ITEM: 6.2	REPORT SUMMARY MINOR VARIANCE APPLICATION FILE NUMBER A007/24
-----------	---

MINOR VARIANCE APPLICATION FILE NUMBER A007/24

CITY WARD #:	2
APPLICANT:	Deepak and Leena Chopra
AGENT:	Lasonne Engineering Ltd. (Daniel Falzon)
PROPERTY:	15 Modesto Valley Court, Woodbridge
ZONING DESIGNATION:	See below.
VAUGHAN OFFICIAL PLAN (2010) DESIGNATION:	Vaughan Official Plan 2010 ('VOP 2010'): "Low-Rise Residential".
RELATED DEVELOPMENT APPLICATIONS:	None
PURPOSE OF APPLICATION:	Relief from the Zoning By-law is being requested to permit a proposed cabana, two pavillions (shown as Pavillion A and Pavillion B on the plan submitted with the application) and reduced rear yard soft landscaping requirements.

PLAN CABANA

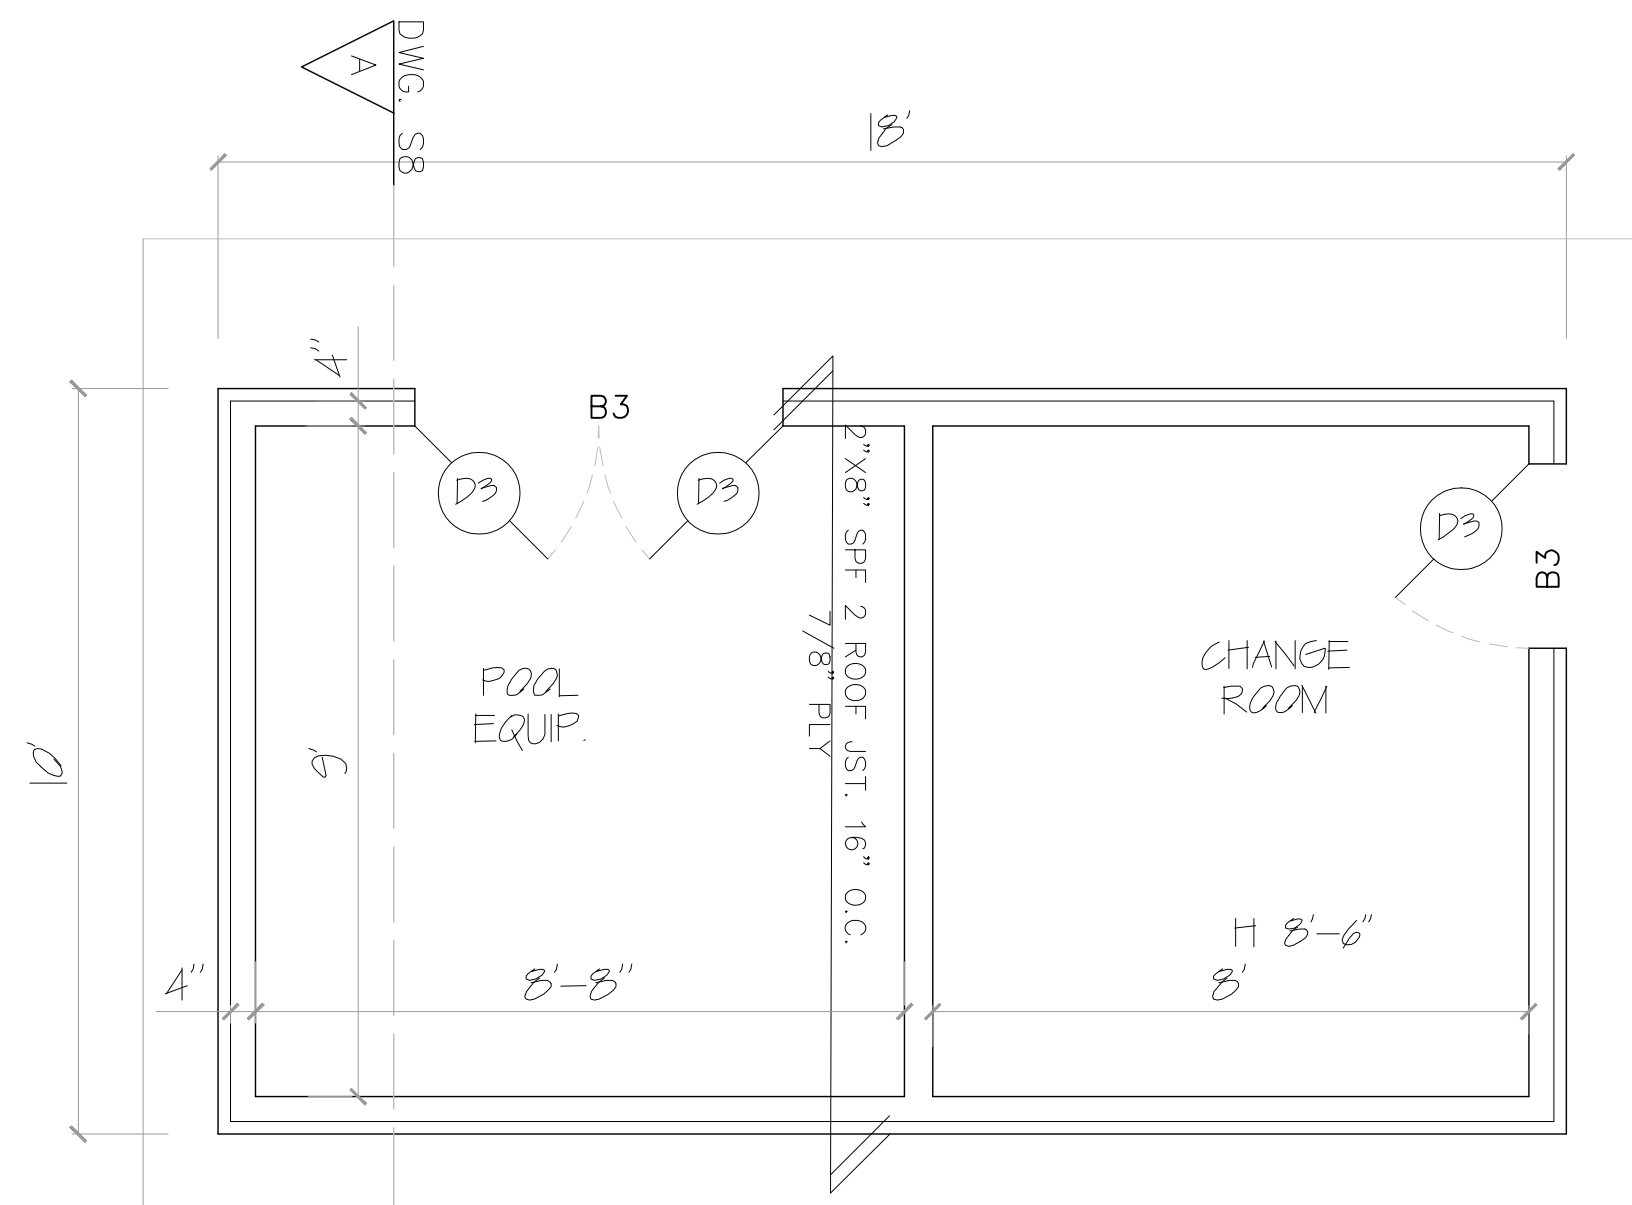
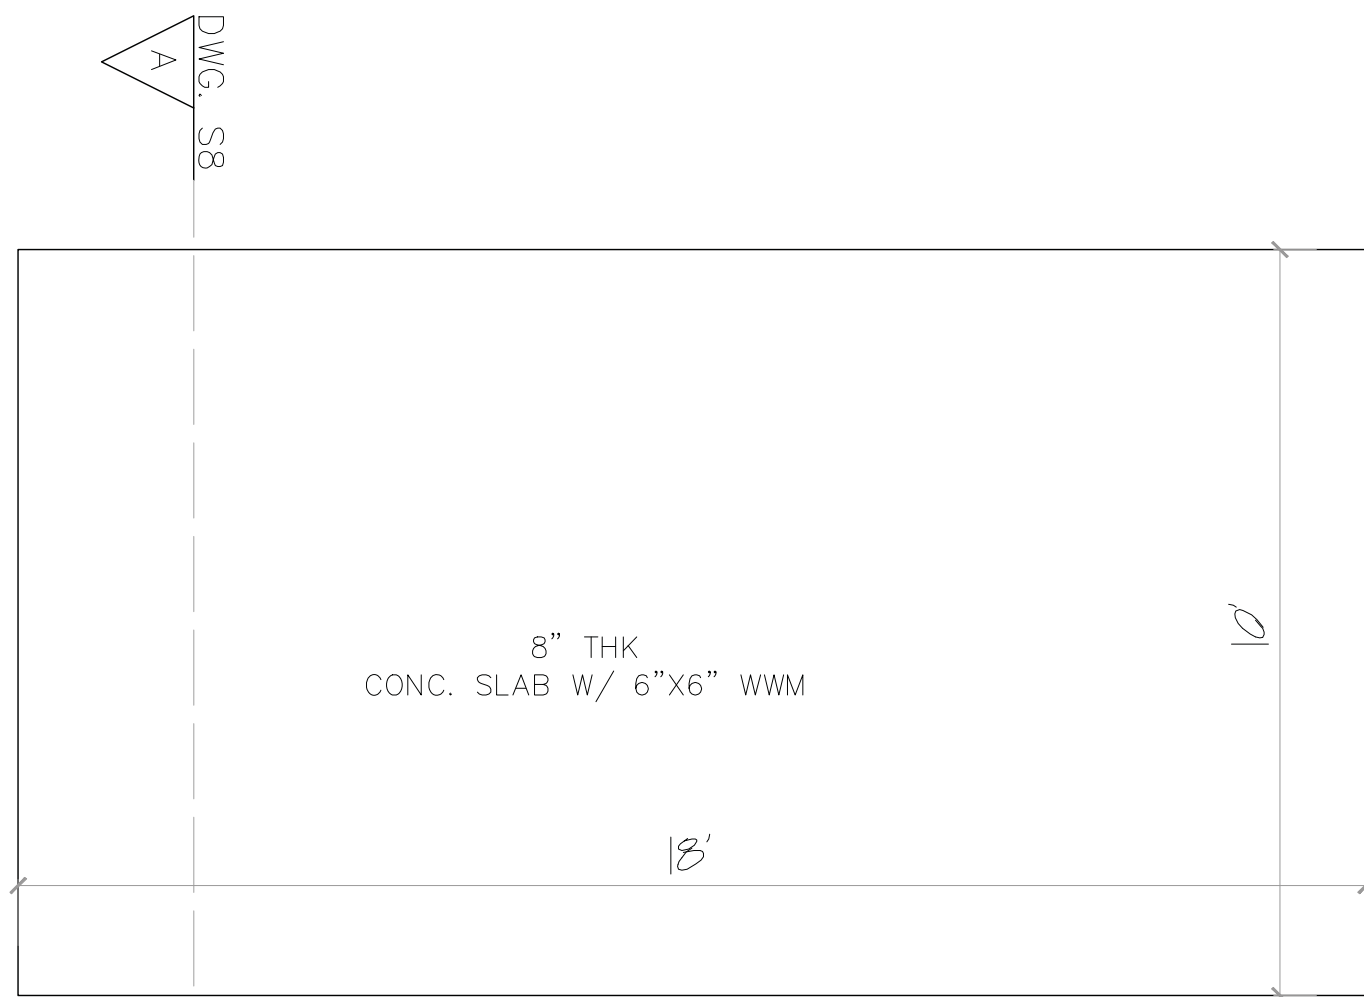
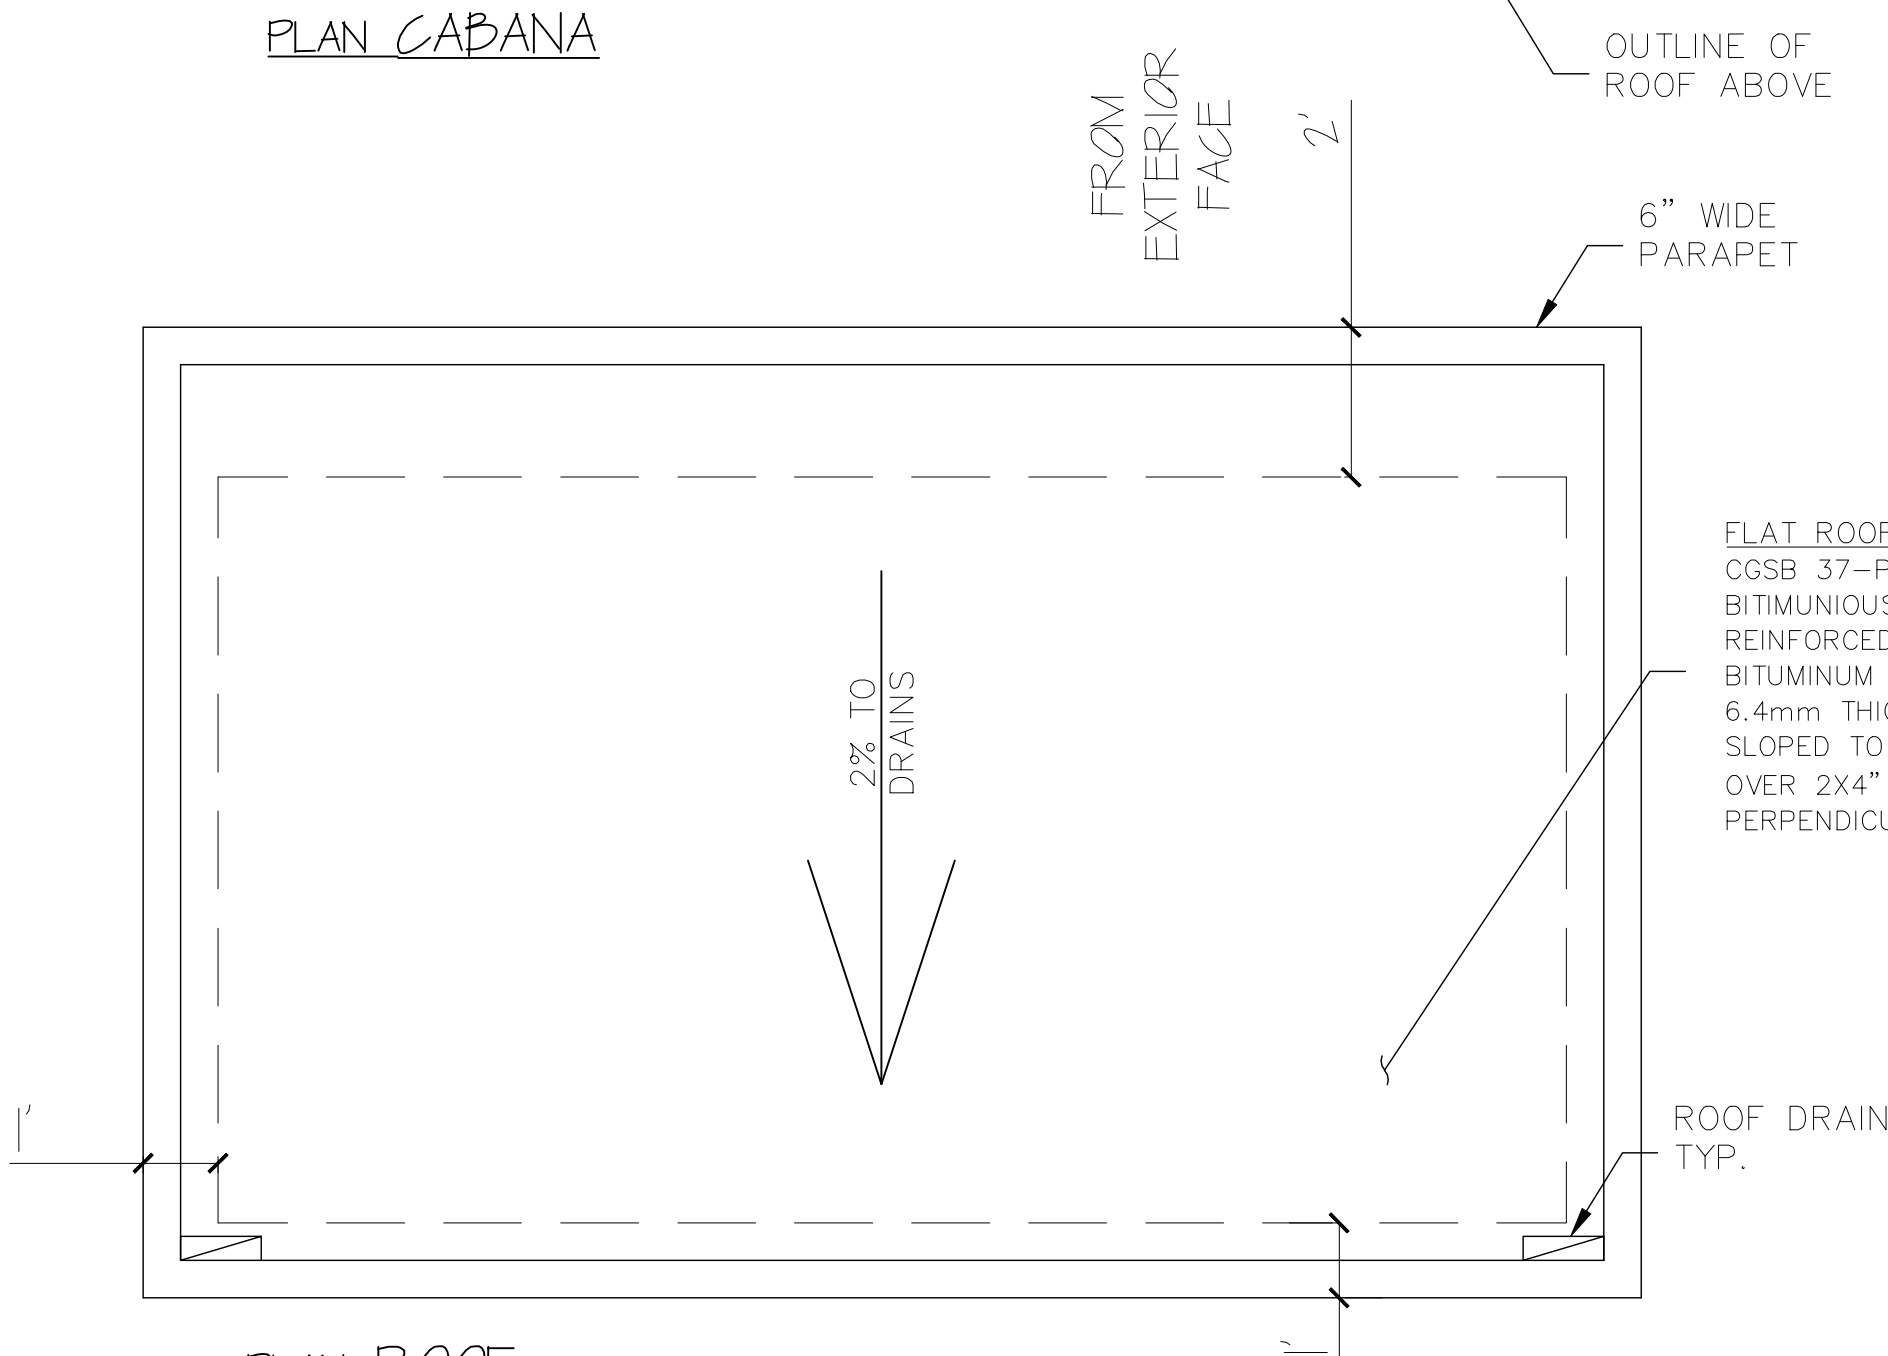
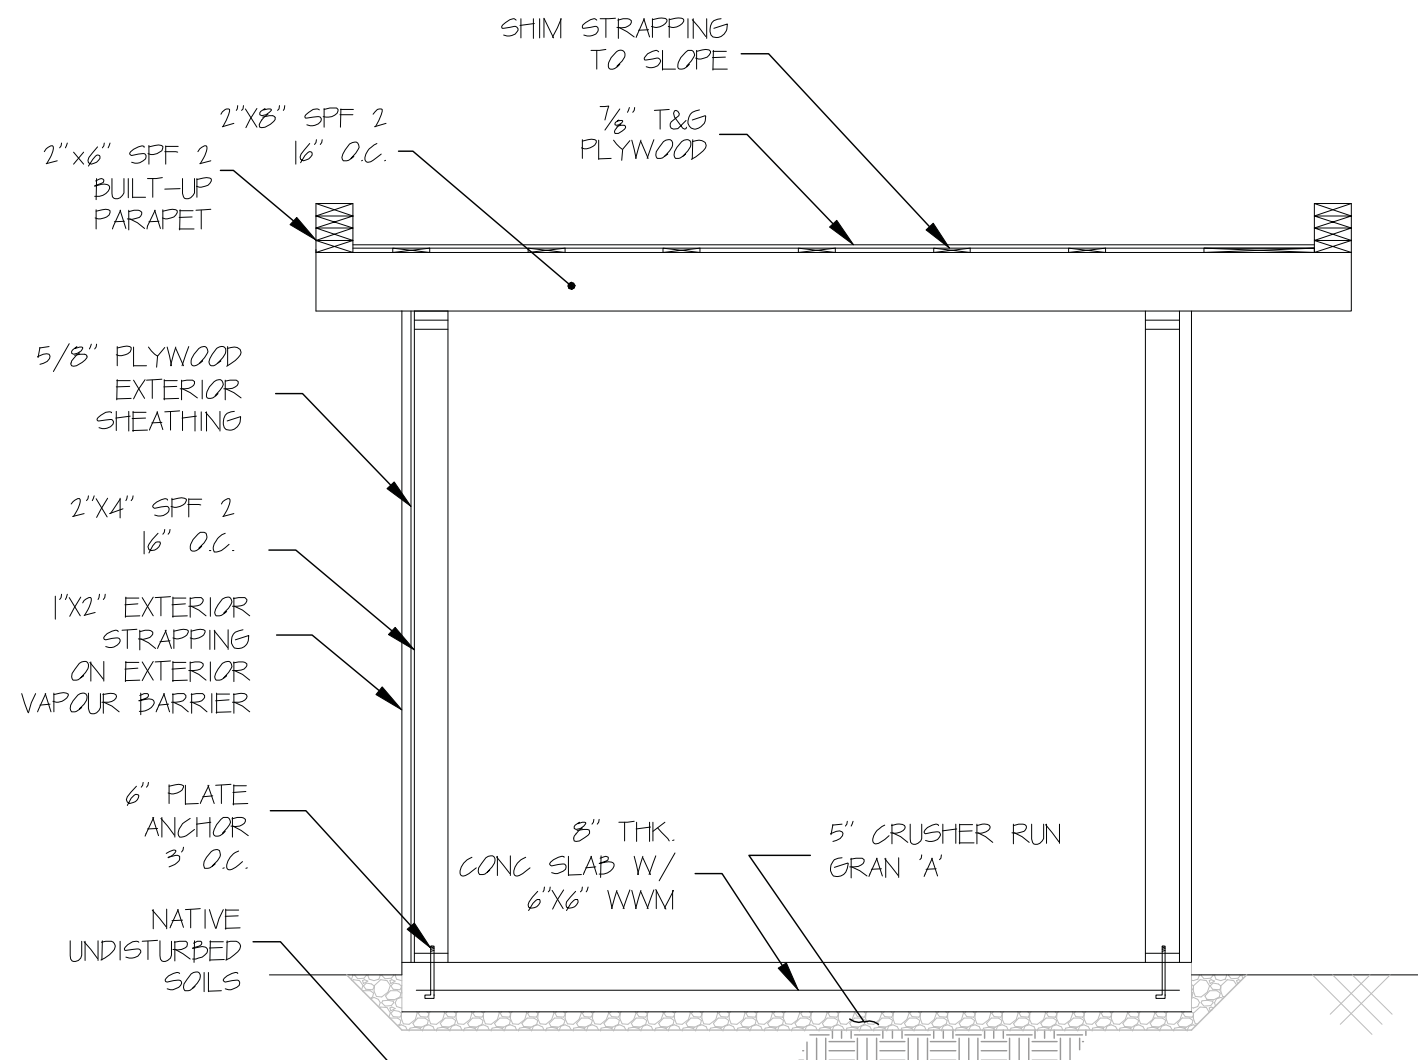
Development Planning Staff have no objection to Variances 1 through 3 to permit a reduced southerly interior side yard setback (Variance 1 – 0.80 m) and a reduced rear yard setback (Variance 2 – 1.90 m) to the existing cabana with a height of 3.14 metres (Variance 3). The proposed 0.14 proposed increase in maximum height for the cabana is relatively negligible from a visual perspective. The cabana is proposed in the south corner of the rear yard and is relatively modest in size with a flat roof to assist in addressing any potential concerns with massing on the neighbouring property to the south (9 Modesto Valley Court). On the neighbouring property to the south (9 Modesto Valley Court), a hard plastic shed and accessory building wall face the southeastern wall of the cabana. The cabana only utilizes the full extent of the requested relief for the interior side yard setback at its southeast corner, which is a pinch-point, increasing to approximately 1.62 metres at its greatest extent at the cabana's southwest corner. Additionally, the existing cabana only utilizes the full extent of the requested relief for the rear yard setback at its southwest corner, which is a pinch-point, increasing to approximately 2.12 metres at its greatest extent at the cabana's south corner.

The rear wall of the cabana abuts an open space containing a meadow and trees. The open space contains no trail access and is therefore not very accessible to the public. Further, no adverse impacts to the function of the open space are anticipated should the variance be granted. Running along the length of the rear lot line (abutting the EP Zone), there is a raised plant bed containing mulch, trees, and yew and boxwood shrubs, which helps provide a natural buffer between the accessory structures along with the patio area, and the abutting open space area. The proposed cabana complies with the maximum lot coverage requirements of the Zoning By-law for accessory buildings and structures. Development Engineering Staff have reviewed the proposal and have no objection. As such, the proposed accessory structure is not anticipated to have adverse use (privacy) or massing impacts on the neighbouring property to the south (9 Modesto Valley Court) or the Environmental Protection (EP) Zone to the west and the 0.80 metre minimum interior side yard setback from the cabana provides sufficient space for maintenance and access purposes.
